**CITY OF BELMONT
PLEASANTS COUNTY, WEST VIRGINIA**

CONTRACT #2 – WATER TREATMENT PLANT UPGRADES

ADDENDUM #2

THRASHER PROJECT #T10-11028

THRASHER
 THE THRASHER GROUP INC.
 CIVIL • ENVIRONMENTAL • CONSULTING • FIELD SERVICES
 1000 CORPORATE LANDING, CHARLESTON, WV 25311
 PHONE (304) 343-7601 • FAX (304) 343-7604

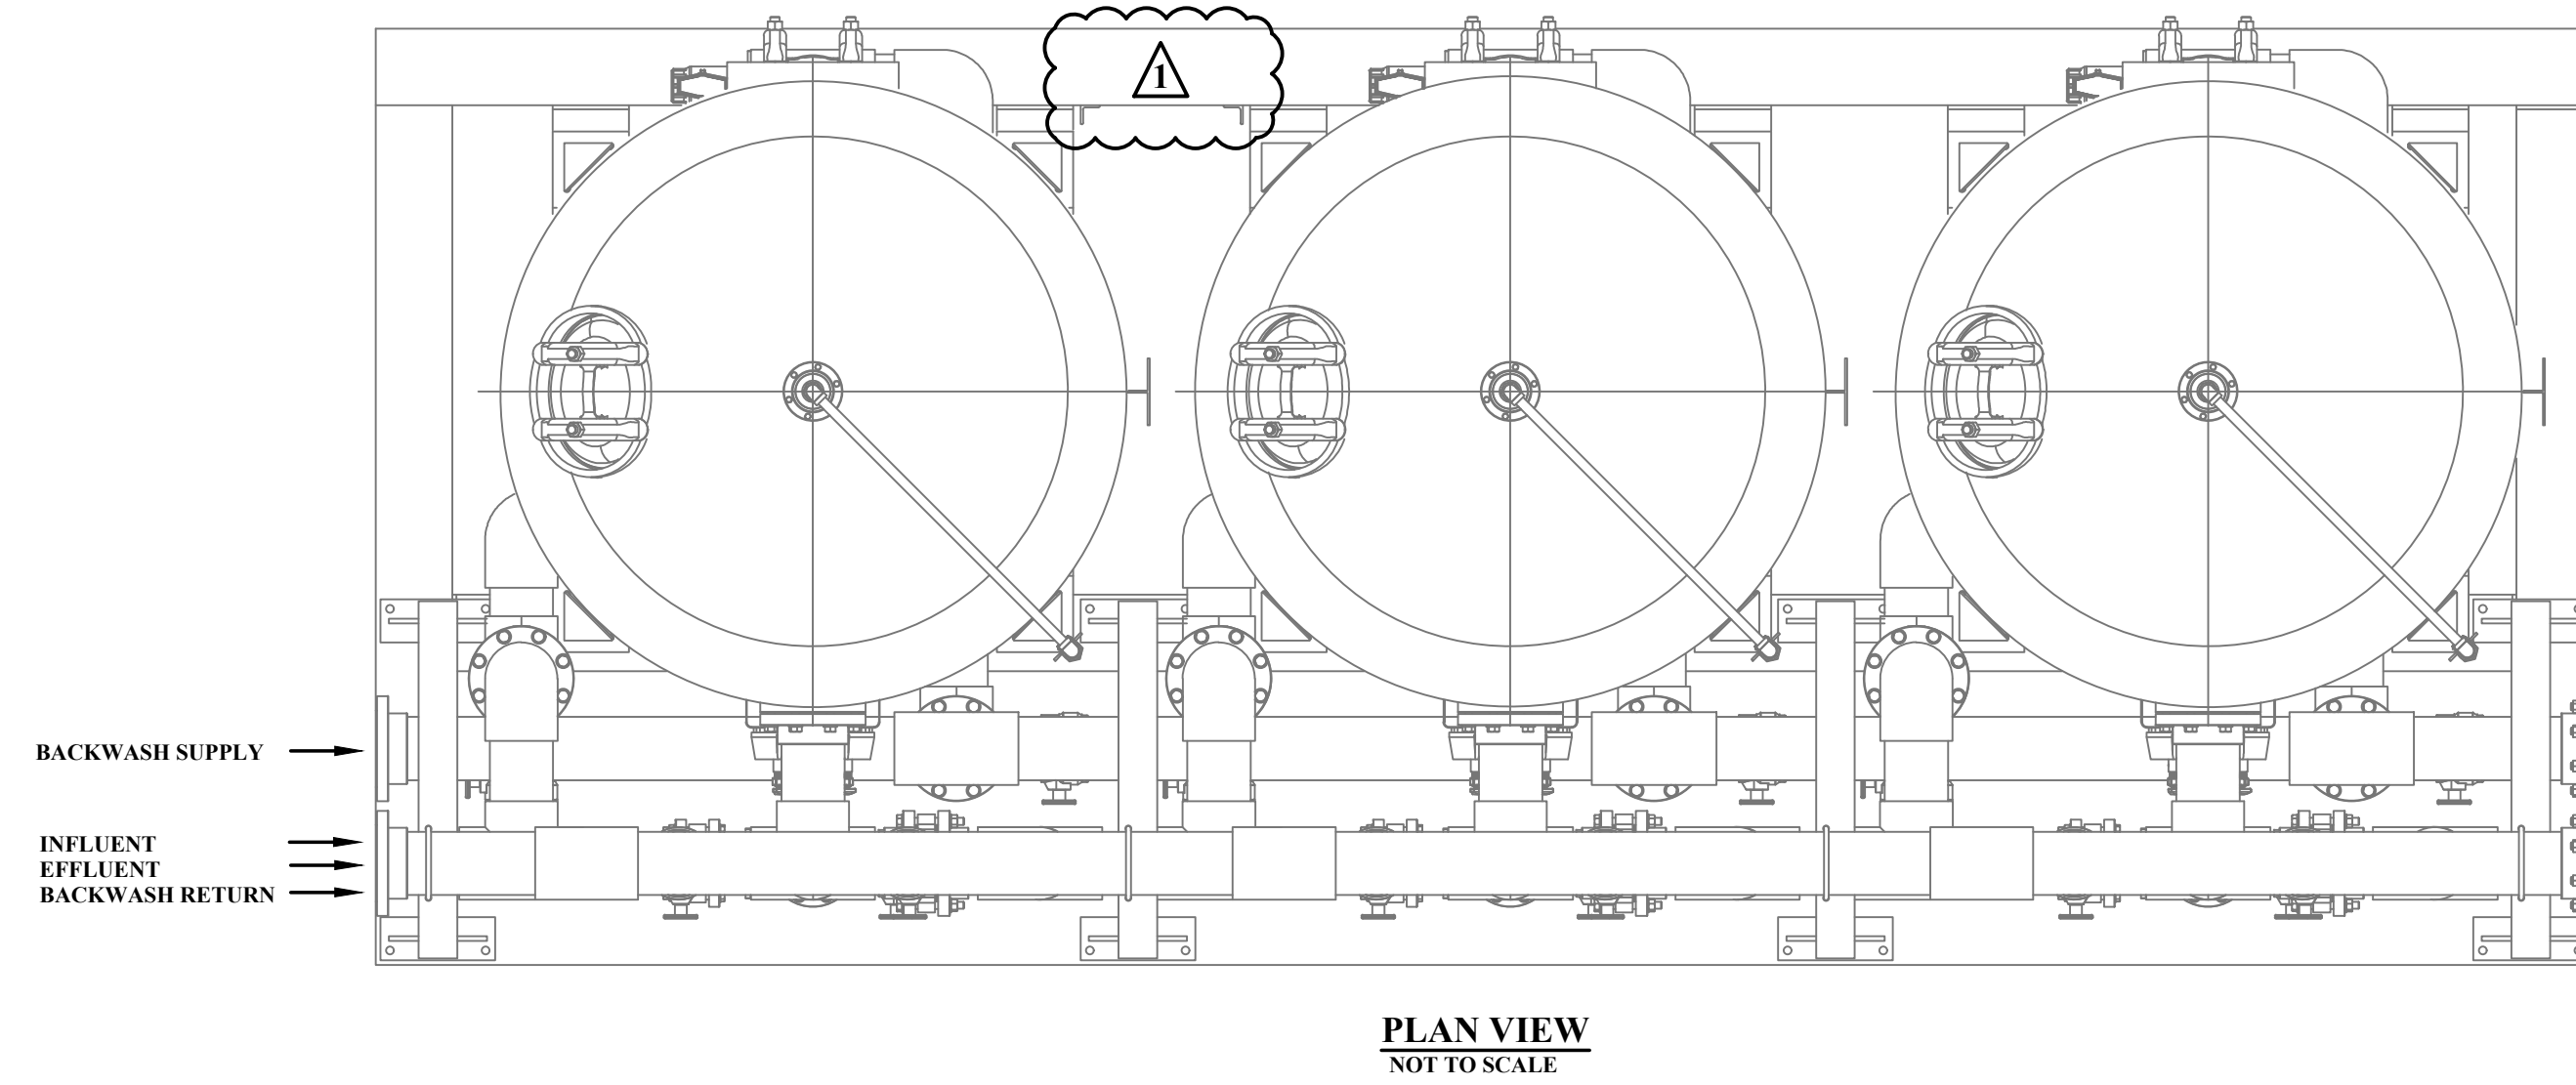
NO.	BY	DATE	DESCRIPTION
1	ISF	7/30/24	ADDENDUM #2 - ADD GEN. NOTE & DEL. NOTE 9 & CONTROL PANEL

NEW FILTER VALVE ACTUATORS PLAN

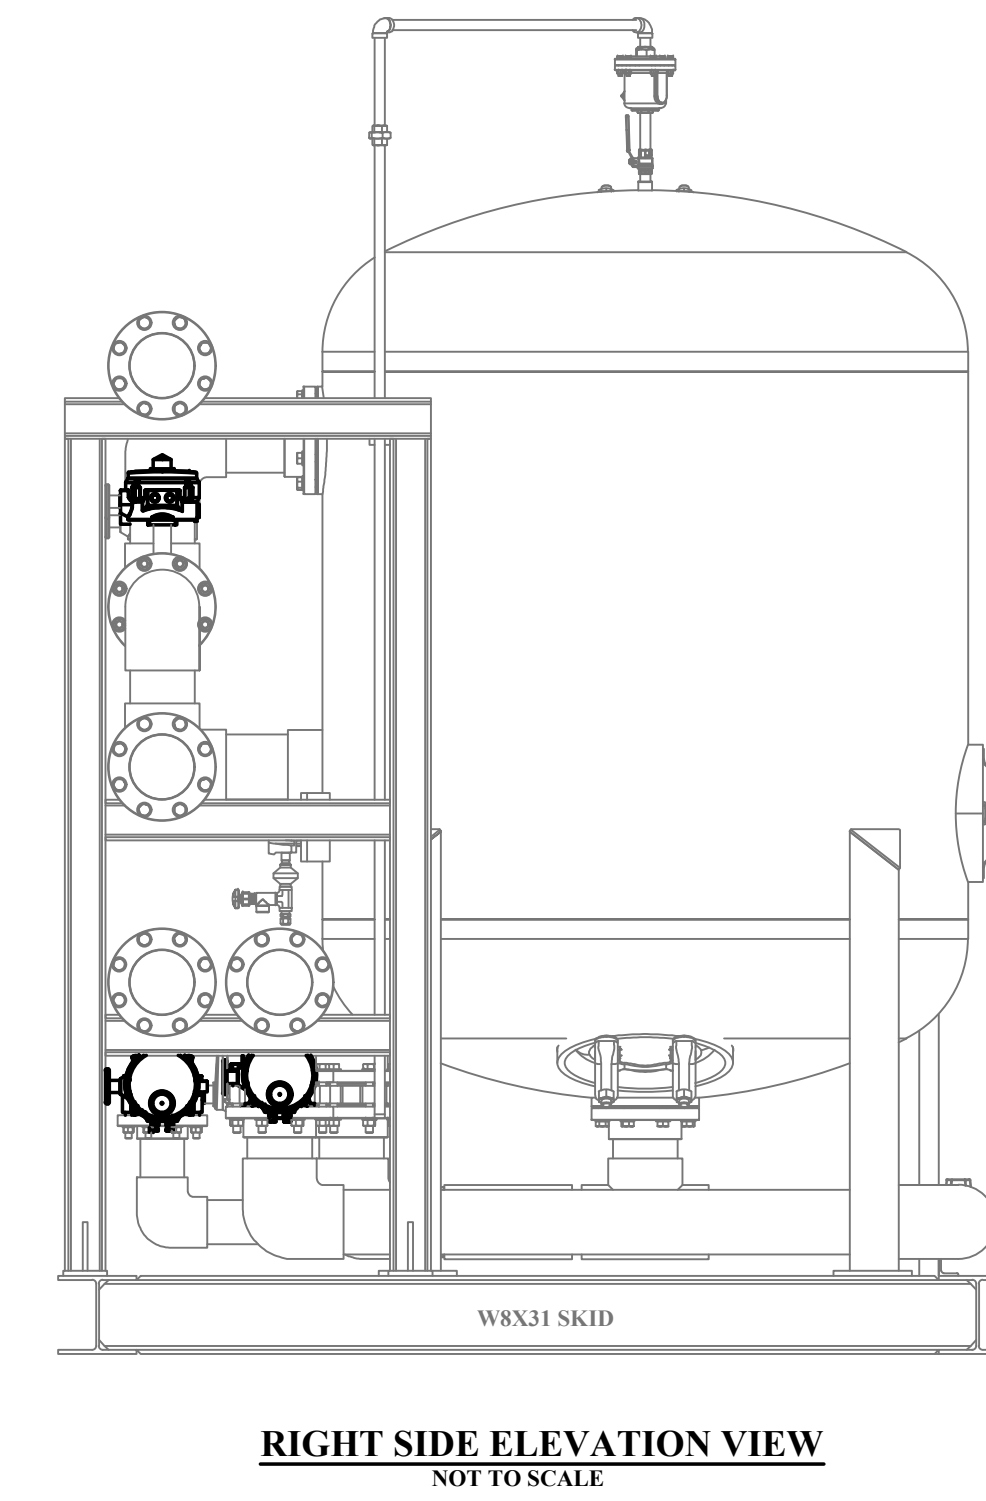
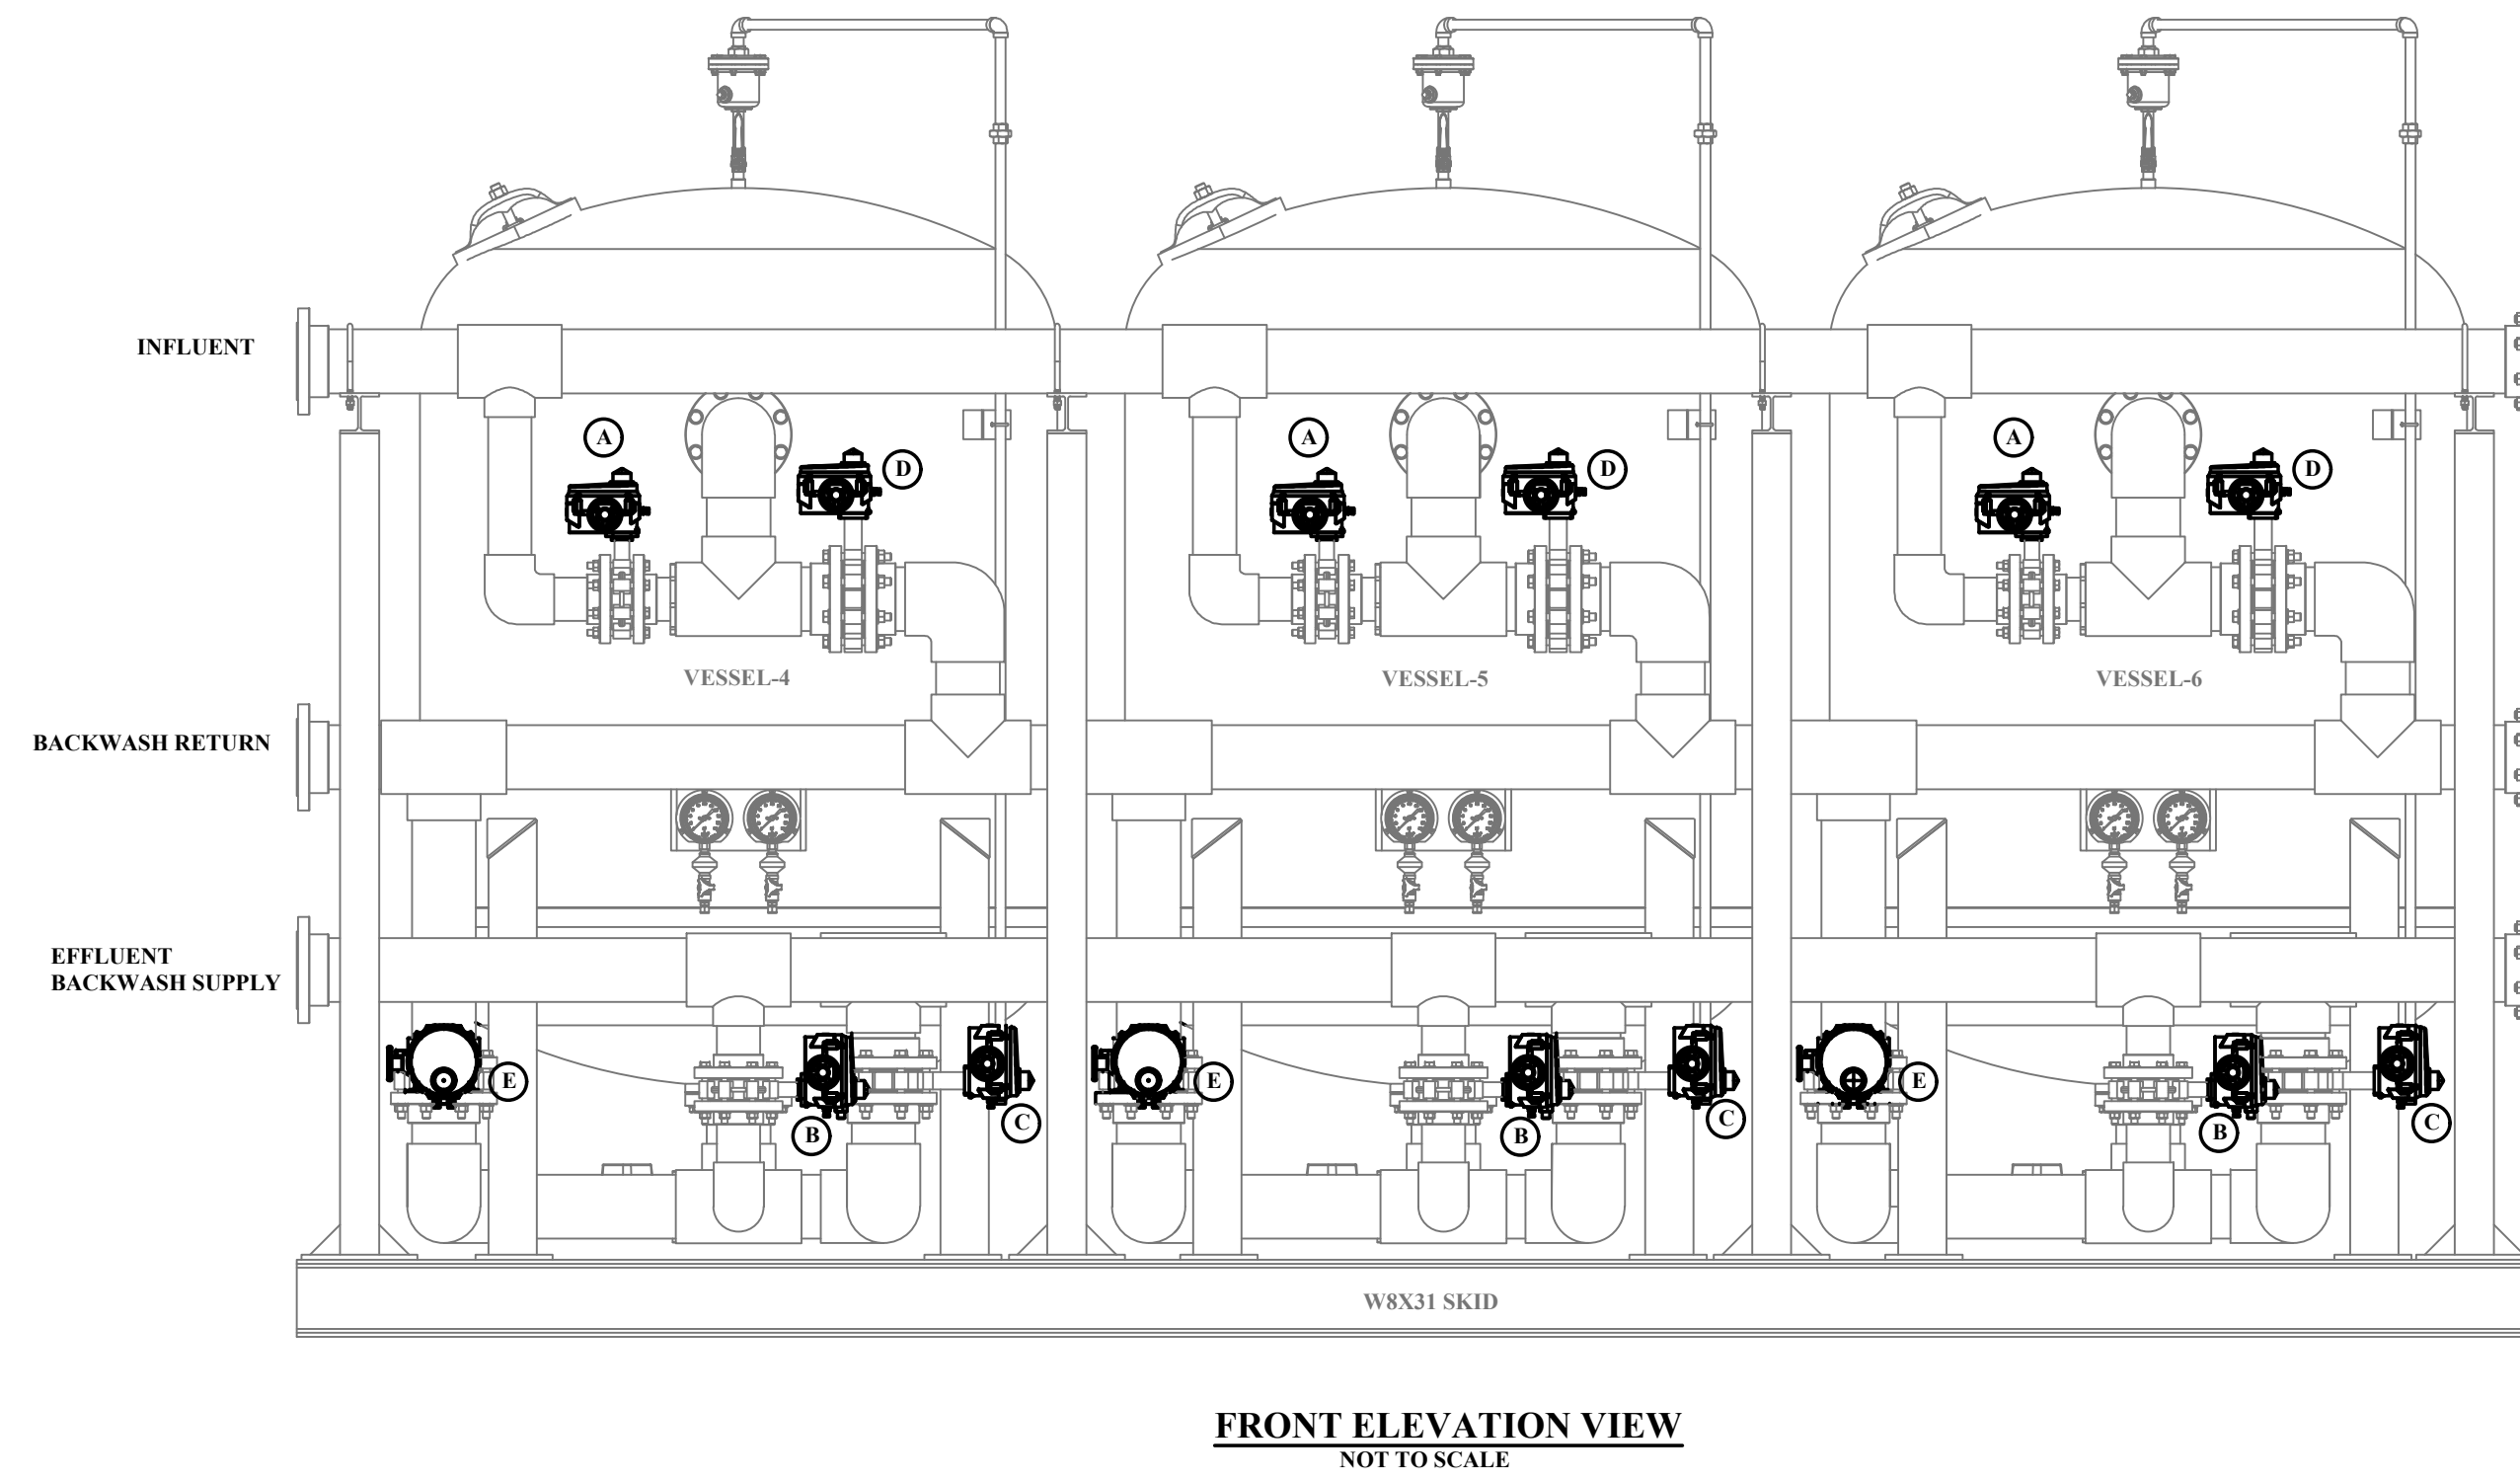
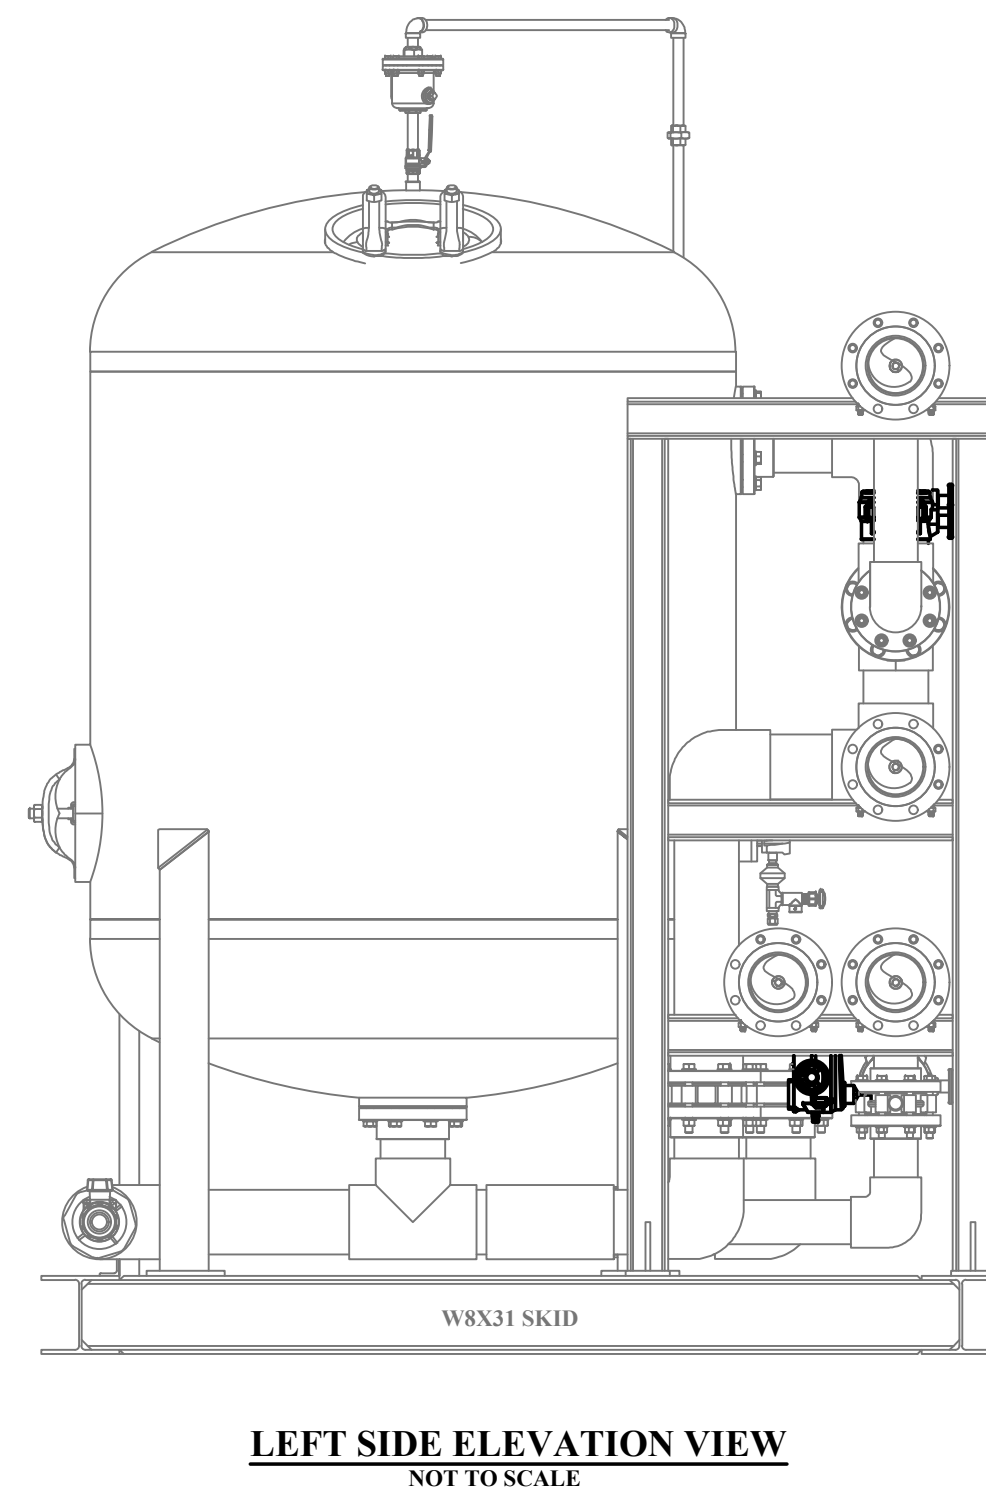
NO.	BY	DATE	DESCRIPTION
1	ISF	7/30/24	ADDENDUM #2 - NOTE "F" REMOVED AND NOTE "H" REVISED
